RESIDENTIAL FLAT BUILDING PEAKHURST

BUILDING CODE OF AUSTRALIA 2022 REPORT

Homes NSW Proposed Residential Flat Building
69 Trafalgar Street & 2 – 6 Gover Street Peakhurst, NSW 2210

Report Ref: 24-221890MCRC_ReportR02_20240820

Figure F4D8: Construction of sanitary compartments

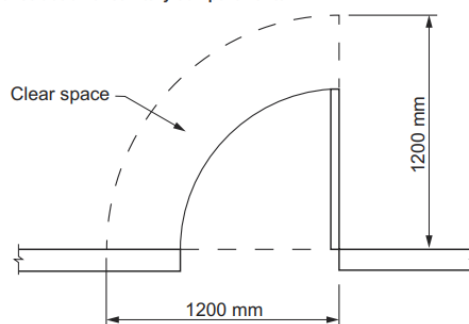
12. **F4D8 (Construction of sanitary compartments)** – Where there is less than 1.2m space as shown in figure F4D8 of the BCA between an inward opening door and the closet pan, the door must be readily removable from the outside (i.e. lift off hinges). **Capable of compliance. Details demonstrating compliance to be provided with the application for s6.28 CDVC.**
